Re: Planning Appeal – 1 Coolnahinch, Dundrum Road, Dublin 14 (D26A/0556/WEB)

I would like to appeal the Planning Authority's decision to REFUSE Permission for the above development.

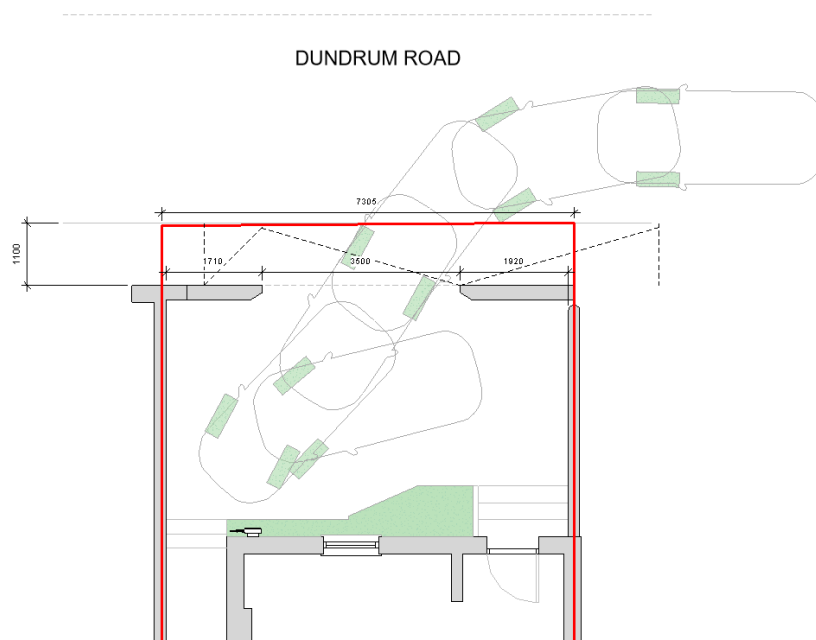
In consideration for this appeal, it is worth noting that the Planners Report noted that the *“Proposed Floor Plans (Drawing No. 005) demonstrated 1no. 4.4m x 2.4m parking space.”* This appears to be an error as the drawing shows a 5.5m x 2.4m parking space in line with the Development plan. The parking space can comfortably fit within the overall width of the curtilage, circa 7.3m. and at its deepest 3.9m.

Below: An image showing the swept path of a vehicle as to how it would enter the site, through the revised 3500mm wide entrance.

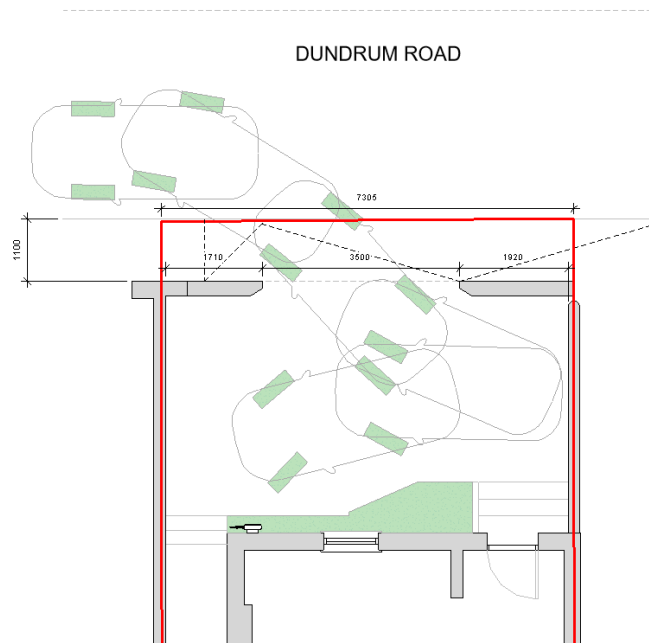
Below: An image showing the swept path of a vehicle as to how it would exit the site, through the revised 3500mm wide entrance.

The previously submitted scheme has been amended to improve vehicle manoeuvrability into and within the site. The revised layout provides a parking bay depth of circa 7.3 metres, and a revised centralised entrance, which allows sufficient space for a vehicle to either drive directly into the parking space or reverse into it, depending on the driver's preference and prevailing traffic conditions. This DIRO or RIDO approach is consistent with the permitted schemes noted above, and on this basis it would be considered that the amended design adequately accommodates the manoeuvring requirements of a private vehicle and facilitates safe access to and from the site.
